ROOF PLUMBING PLAN
3/16" = 1'-0"

28 W DILDO RESIDENCE
28 WEST DILDO DR.
MIAMI BEACH, FL 33139

sheet no.
P-3.0

NATURAL GAS RISER DIAGRAM
N.T.S.

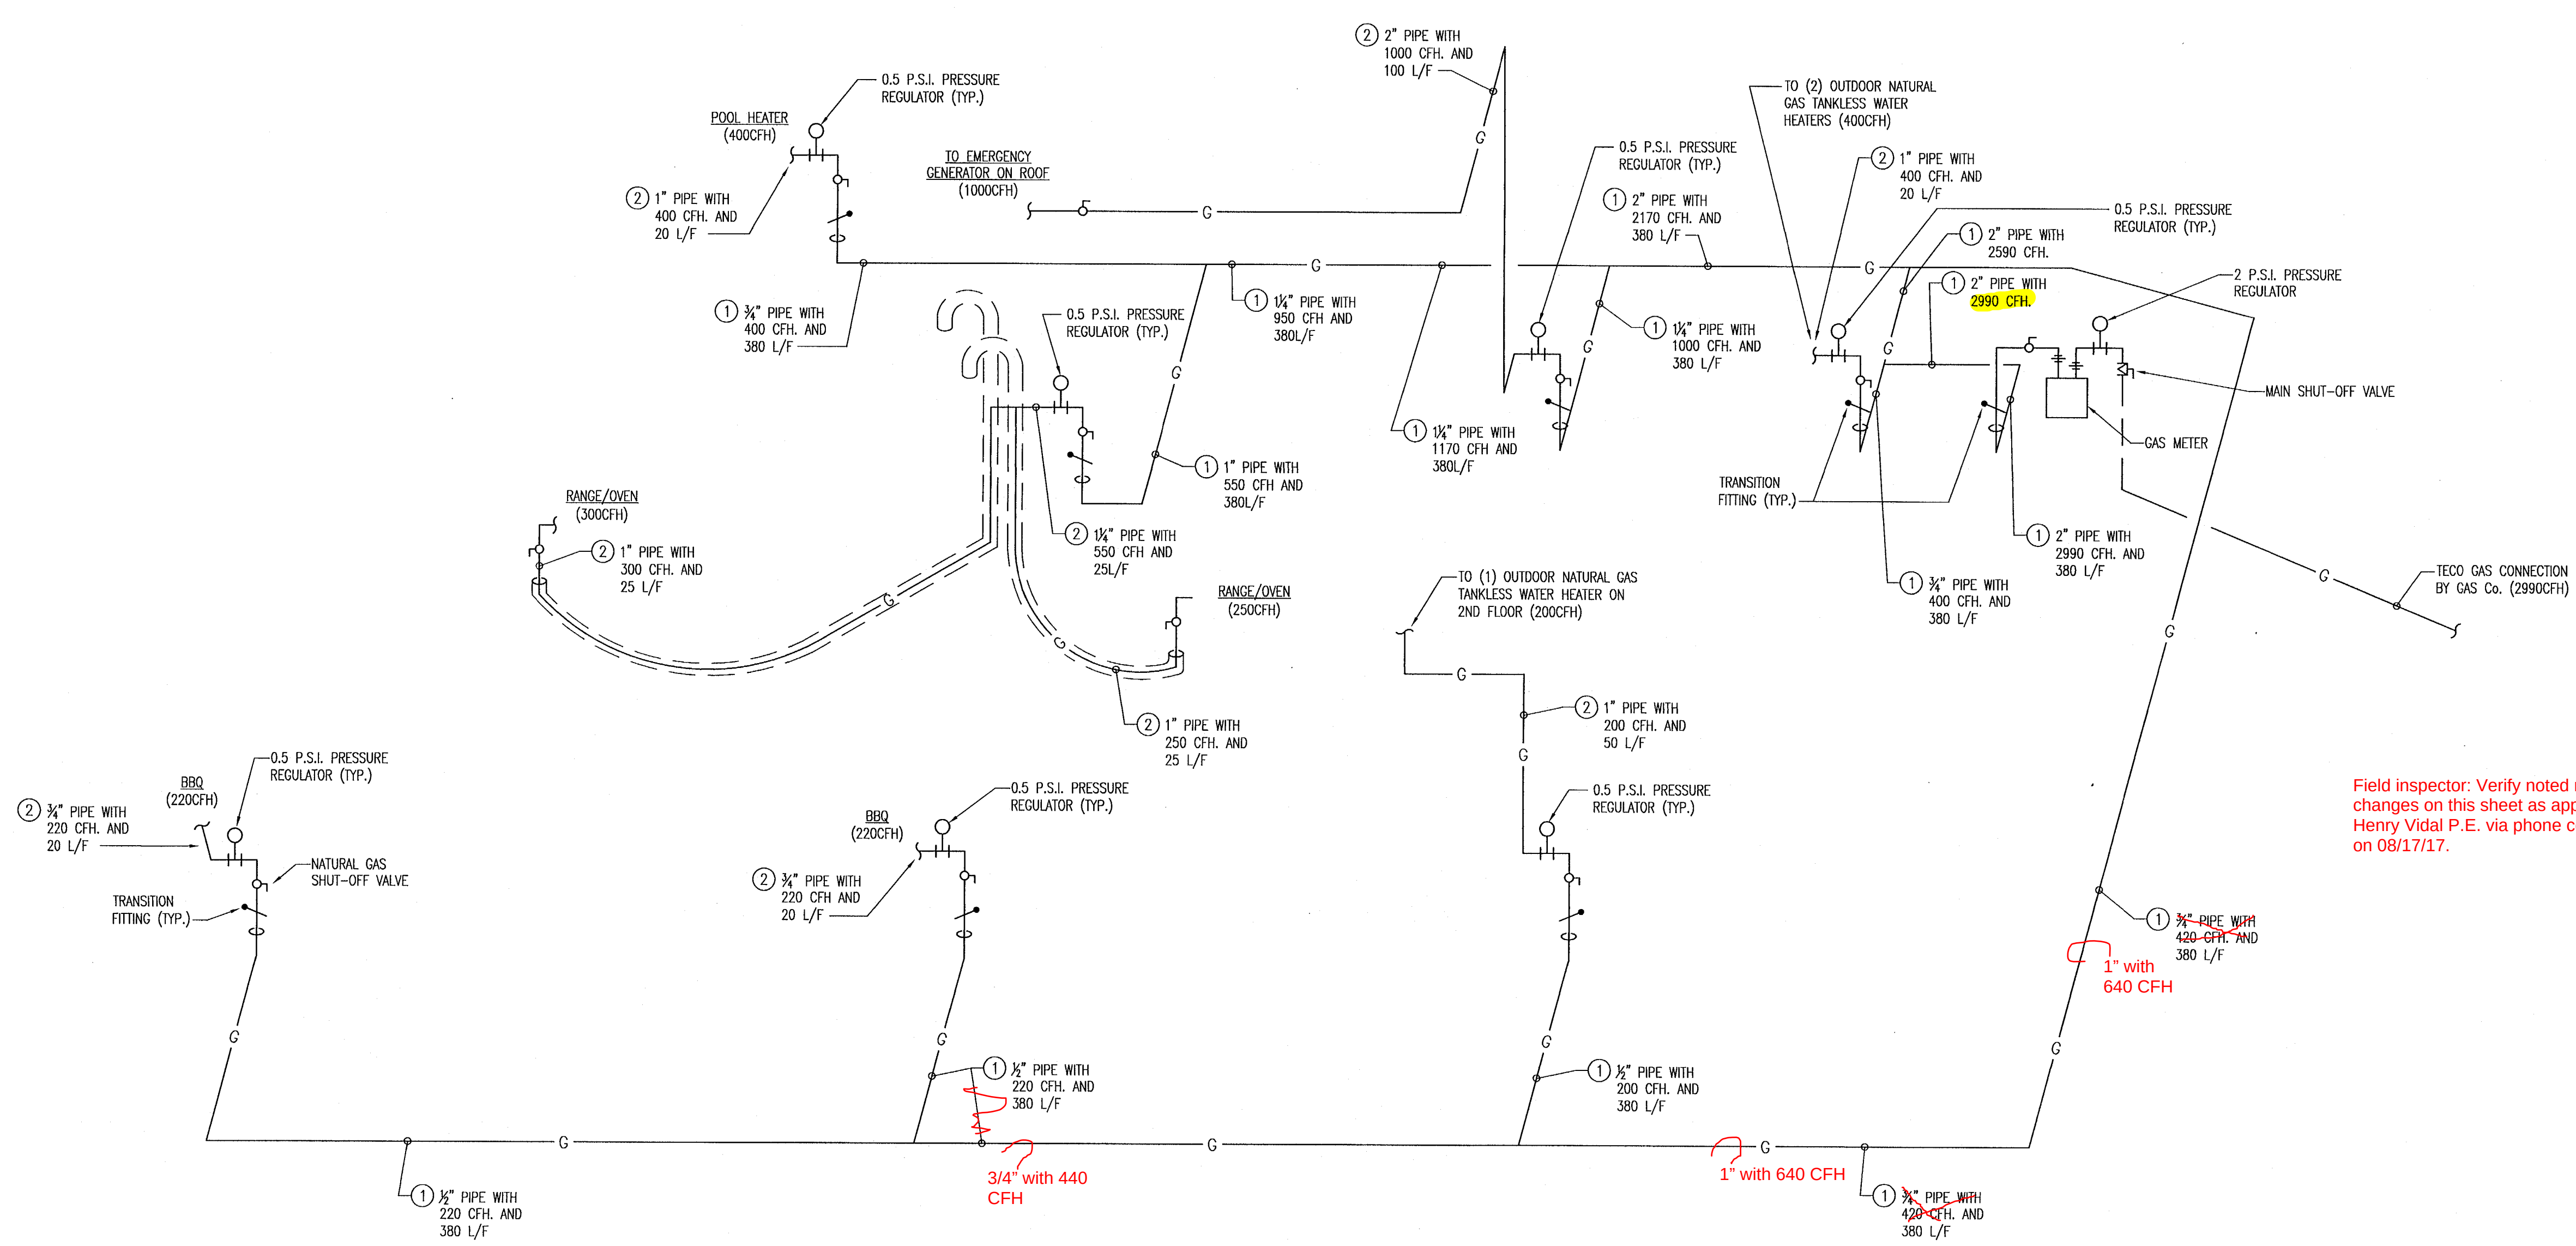
Field inspector: Verify noted red line changes on this sheet as approved by Henry Vidal P.E. via phone conversation on 08/17/17.
